TYPE NO <b>H&amp;C</b>	TYPE <b>FB55 - 7100 - CV7200/7300 – 7300 - 7600</b>	T.I. NO <b>05 - 2014</b>				
SERIAL NUMBERS AFFECTED	<b>From and including S/N (see table included)</b>	ISSUED BY <b>Documentation/N&amp;W Valbrembo</b>				
SUBJECT <b>NEW POSTER DEMB NETHERLANDS</b>	ISSUED FOR (X): <table border="1"> <tr> <td>Action</td> <td></td> </tr> <tr> <td>Information</td> <td><b>X</b></td> </tr> </table>		Action		Information	<b>X</b>
Action						
Information	<b>X</b>

Poster Frame –New situation ONLY  
for The Netherlands

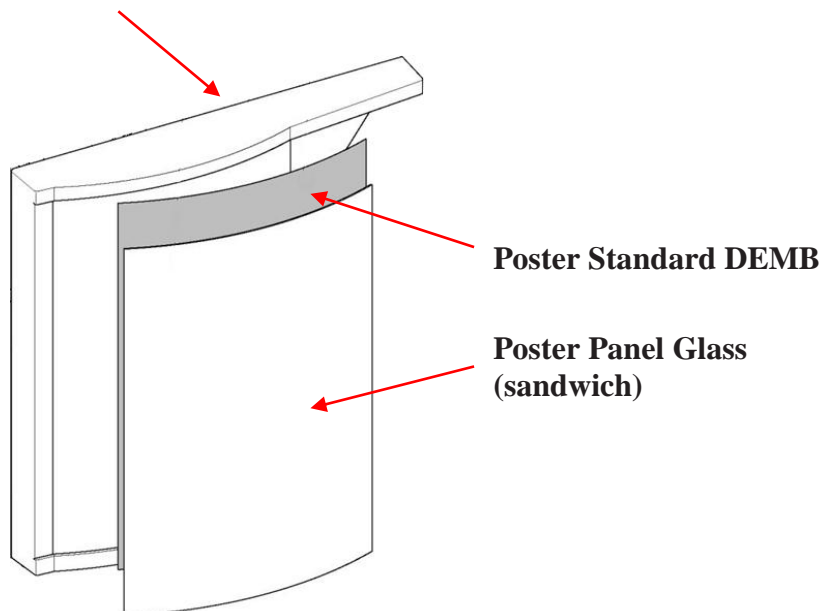
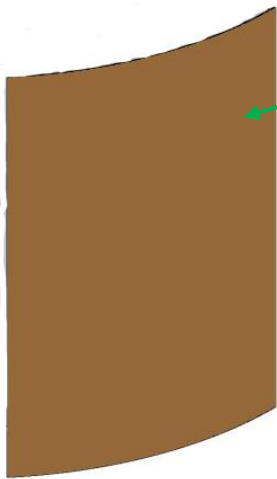
Due to a new aesthetical request for the Netherlands market, a new Poster has been introduced. Below a picture of the old “Poster Frame Assembly”: Poster Frame + a **Sandwich** made by

The new Poster “**Black background and beans DEMB**” is no longer a sandwich made of two pieces, but it’s a single graphic panel directly mounted in the door of the machines above mentioned.

The poster material (PVC treated) is different from the previous one due to the direct contact with the final user in front of the machine.

The new Poster can be installed in all the Gallery Coffee Vending machines prior to the above mentioned serial number: have to be removed the old poster and the poster panel glass related (plus the poster opaline where installed – ES PREMIO) and installed directly in the machine front door.

## Gallery 420

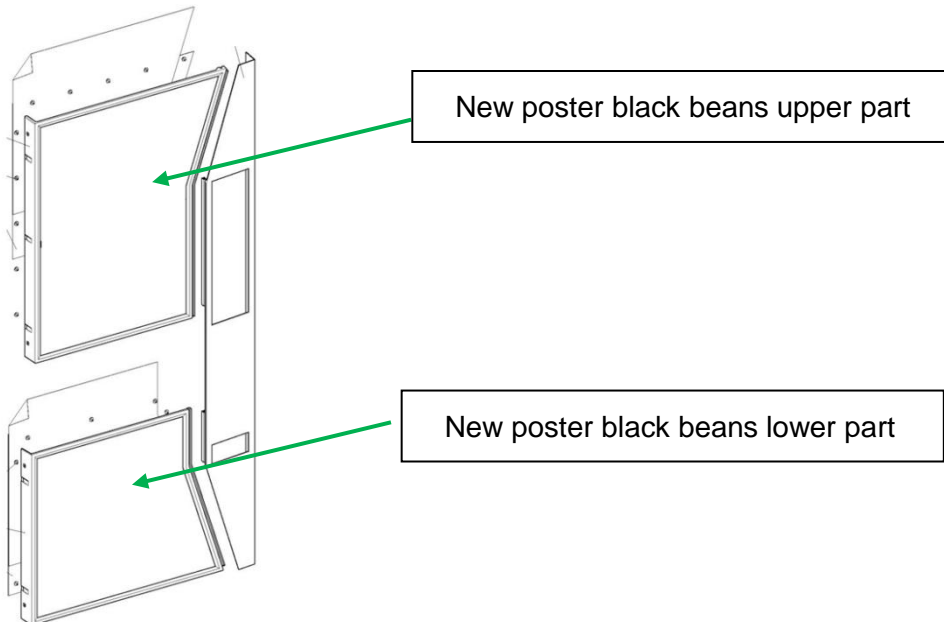
For machine as Gallery 110 and Gallery 420 the poster material is the same, has changed only the layout for the Dutch machine (see below in the table the details in term of codes and version).
